CITY OF MADISON

PLAN OF PROPOSED IMPROVEMENT

2102-2202 DARWIN ROAD CSM

REVISION 1: 11/20/2024
- REVISED SHEETS: U1-U4

14973
MADISON, WI
9484
CONTRACT NO.:
SEWER PLAN AND PROFILE - DARWIN ROAD
2102-2202 DARWIN ROAD CSM
M:\DESIGN\Projects\14973\CAD\Sewers\14973SWR-PipeNetwork.dwg
14973
U-1

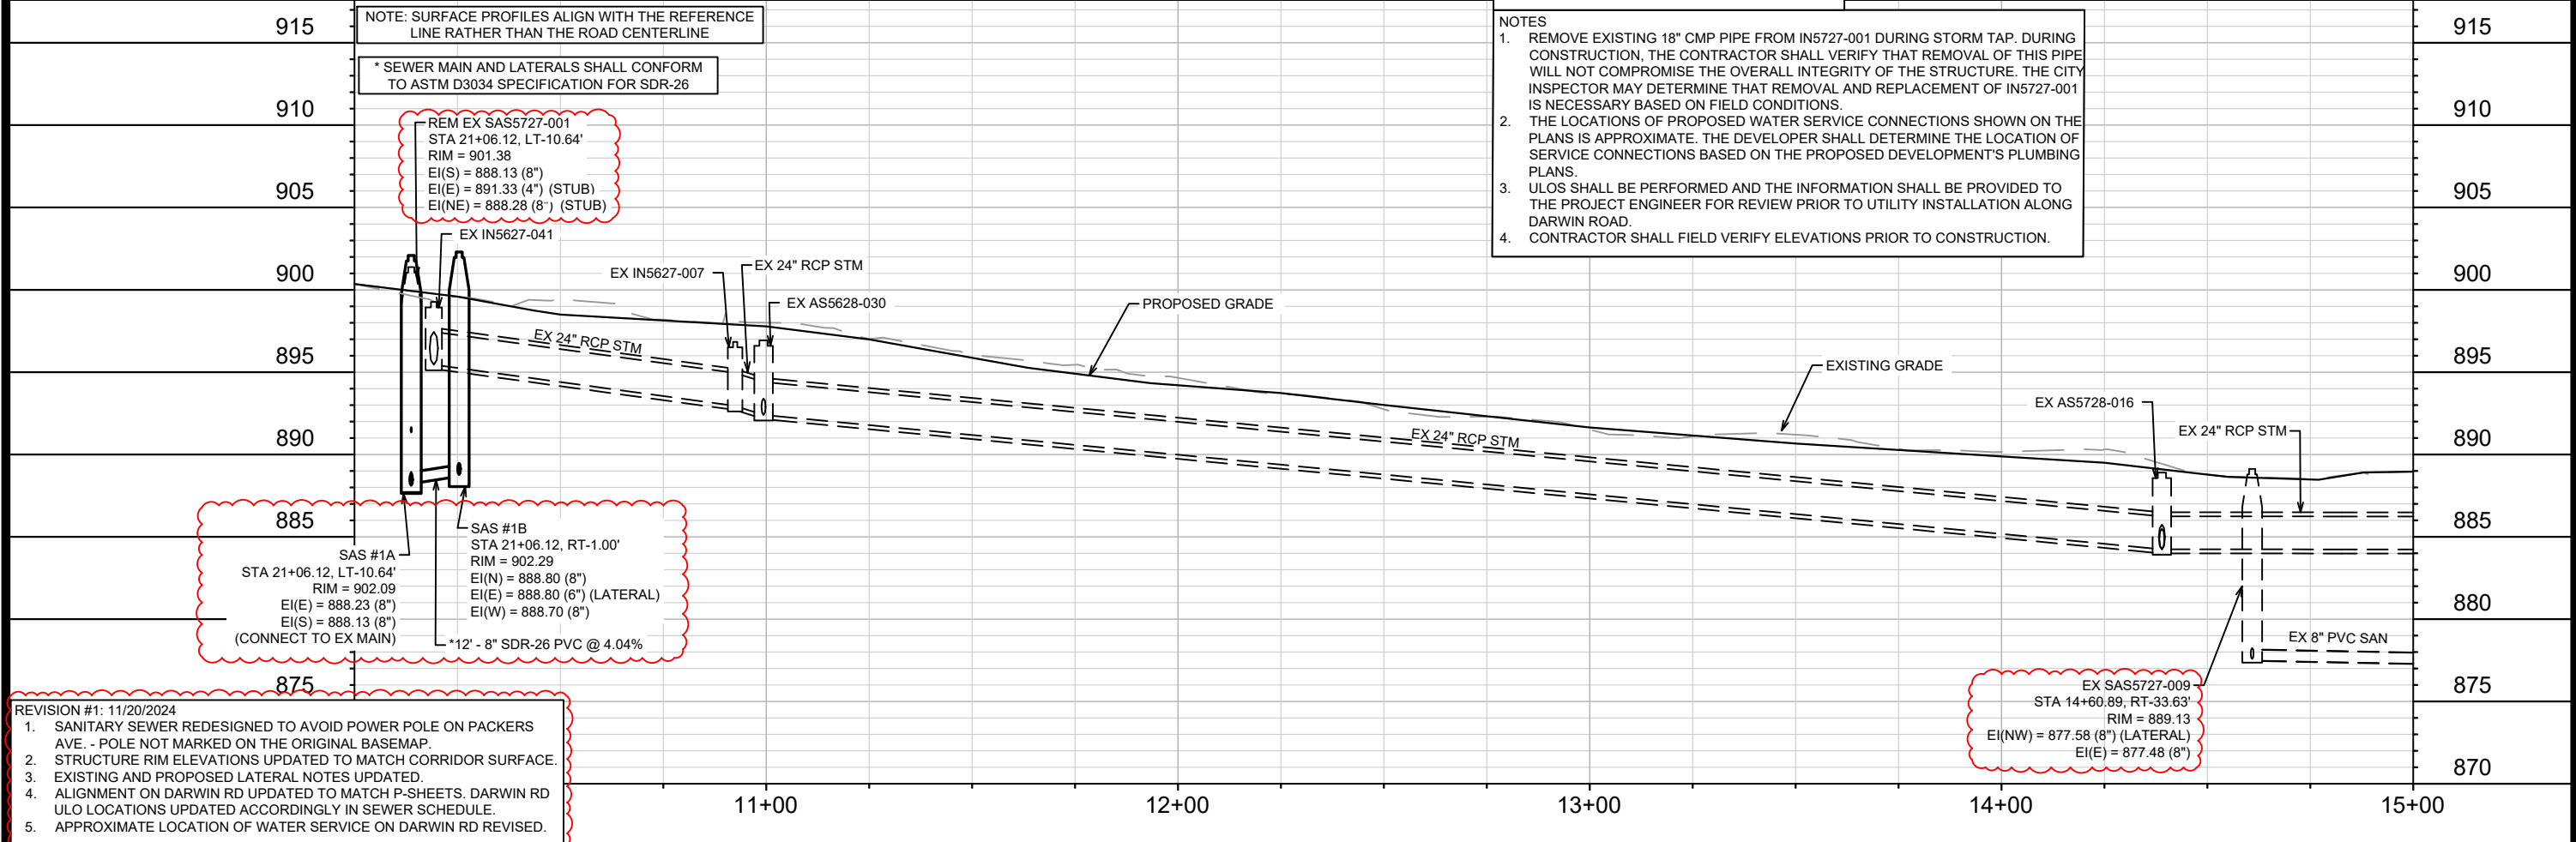
- REVISION #1: 11/20/2024**
1. SANITARY SEWER REDESIGNED TO AVOID POWER POLE ON PACKERS AVE. - POLE NOT MARKED ON THE ORIGINAL BASEMAP.
 2. STRUCTURE RIM ELEVATIONS UPDATED TO MATCH CORRIDOR SURFACE.
 3. EXISTING AND PROPOSED LATERAL NOTES UPDATED.
 4. ALIGNMENT ON DARWIN RD UPDATED TO MATCH P-SHEETS. DARWIN RD ULO LOCATIONS UPDATED ACCORDINGLY IN SEWER SCHEDULE.
 5. APPROXIMATE LOCATION OF WATER SERVICE ON DARWIN RD REVISED.

SEWER PLAN AND PROFILE - PACKERS AVENUE
2102-2202 DARWIN ROAD CSM
M:\DESIGN\Projects\14973\CAD\Sewers\14973SWR-PipeNetwork.dwg

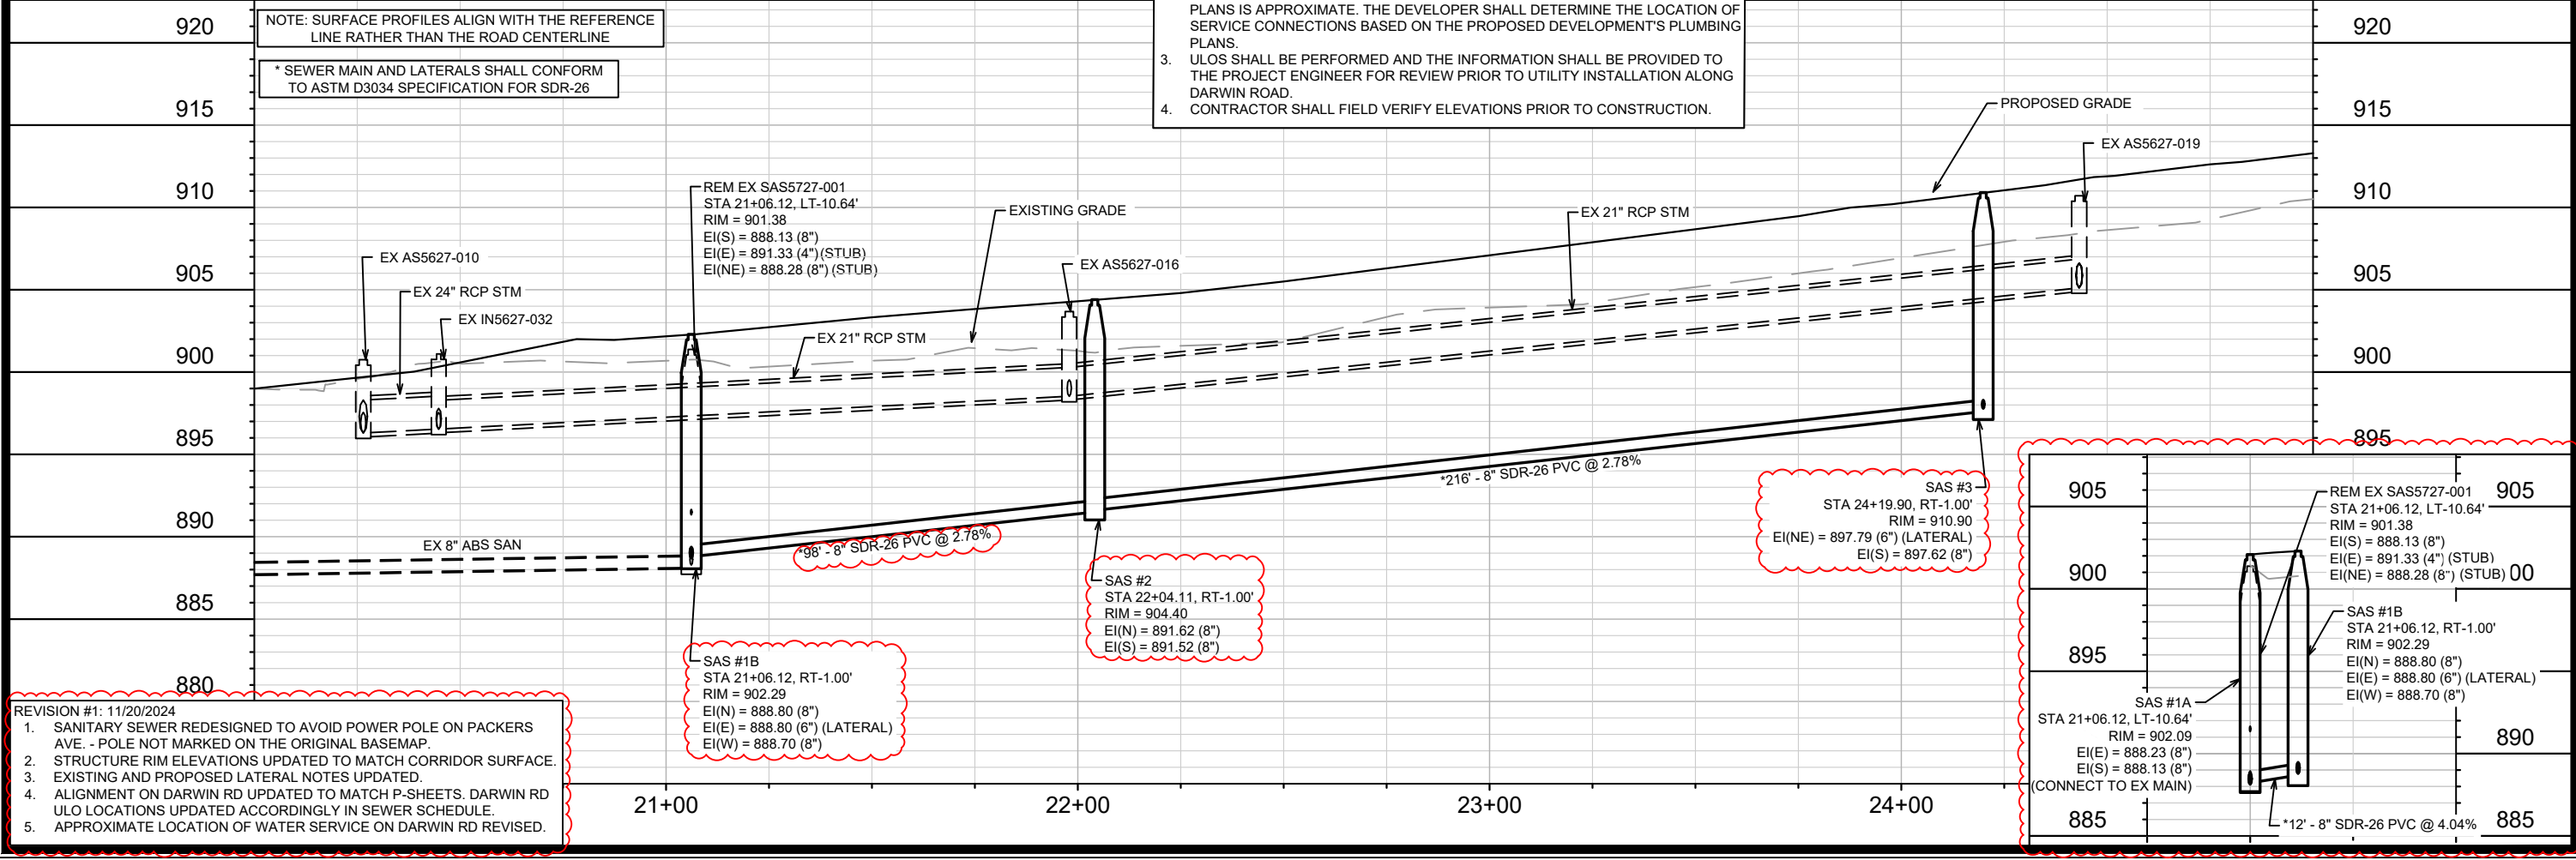
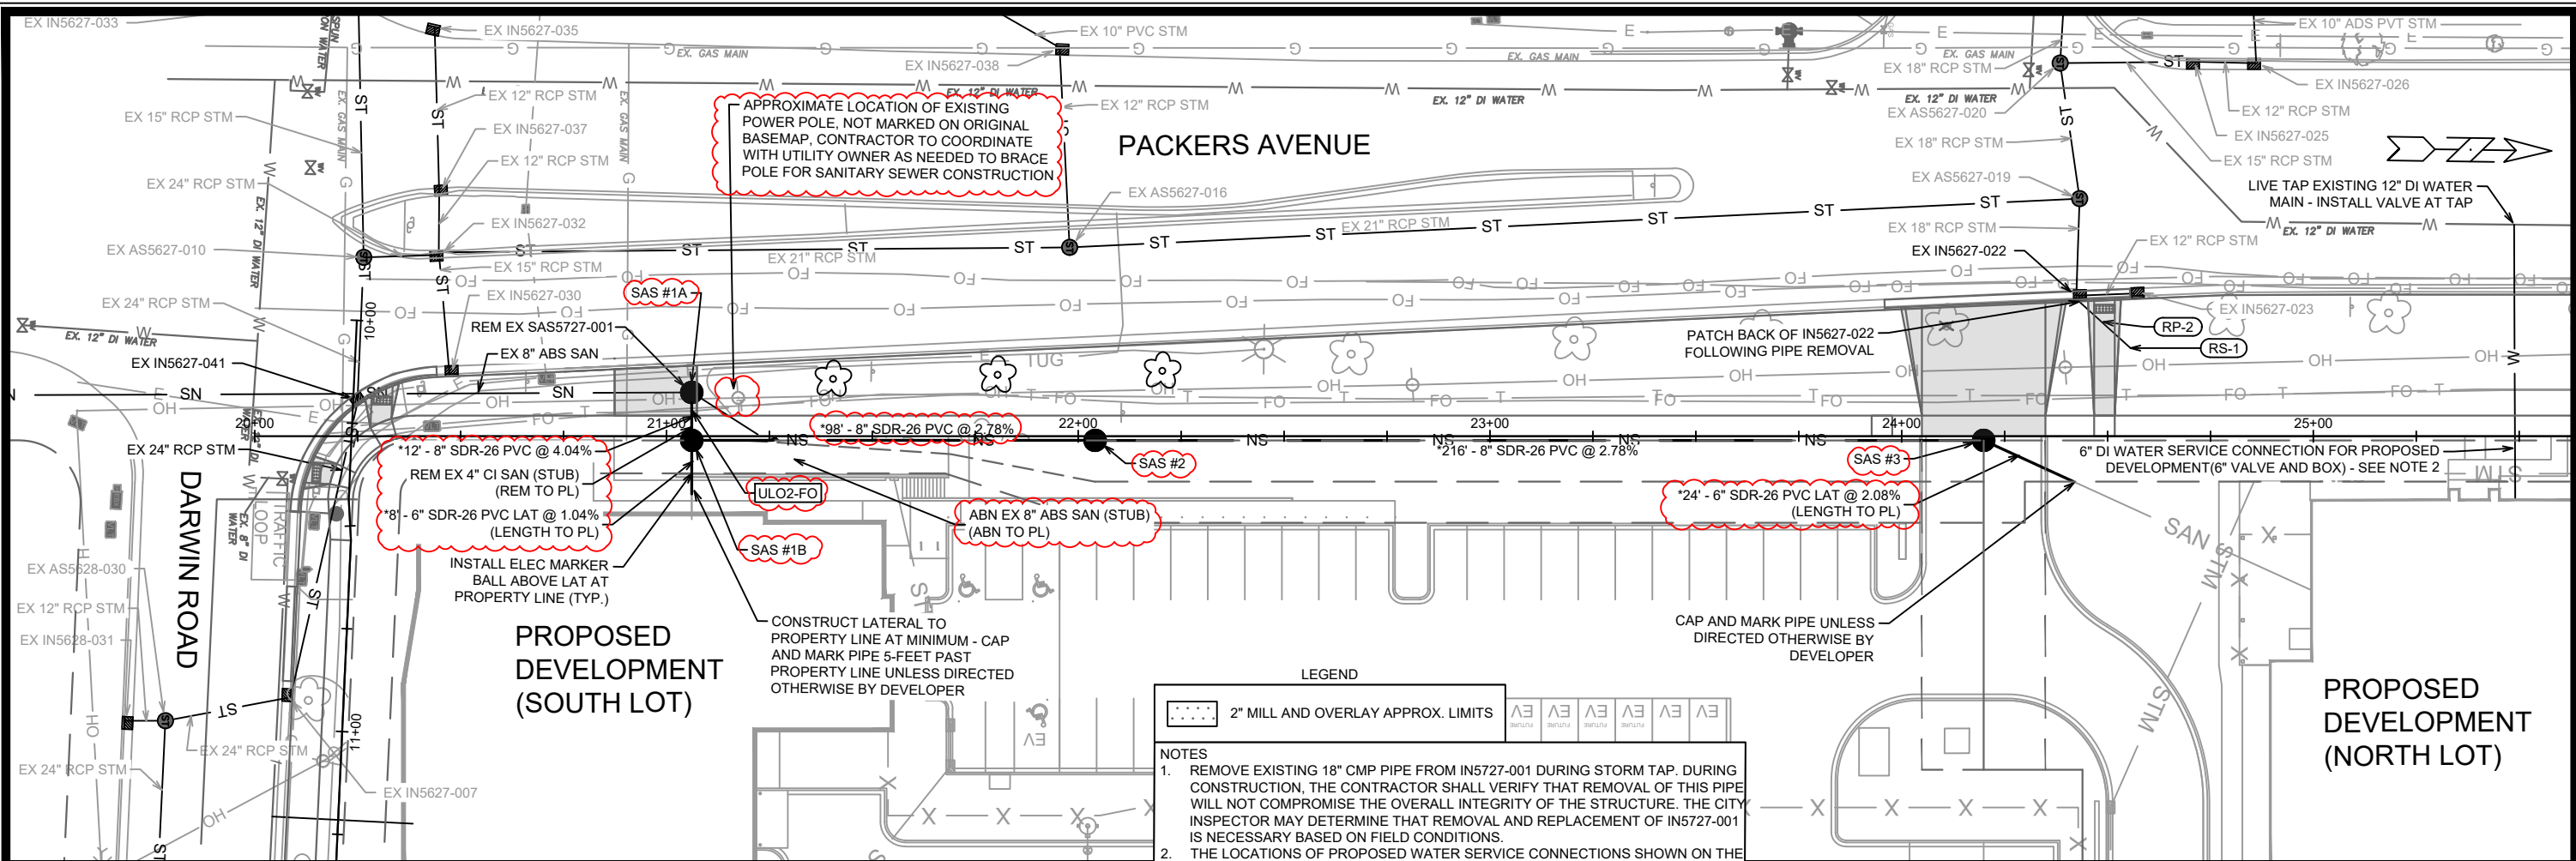
- REVISION #1: 11/20/2024
- SANITARY SEWER REDESIGNED TO AVOID POWER POLE ON PACKERS AVE. - POLE NOT MARKED ON THE ORIGINAL BASEMAP.
 - STRUCTURE RIM ELEVATIONS UPDATED TO MATCH CORRIDOR SURFACE.
 - EXISTING AND PROPOSED LATERAL NOTES UPDATED.
 - ALIGNMENT ON DARWIN RD UPDATED TO MATCH P-SHEETS. DARWIN RD ULO LOCATIONS UPDATED ACCORDINGLY IN SEWER SCHEDULE.
 - APPROXIMATE LOCATION OF WATER SERVICE ON DARWIN RD REVISED.
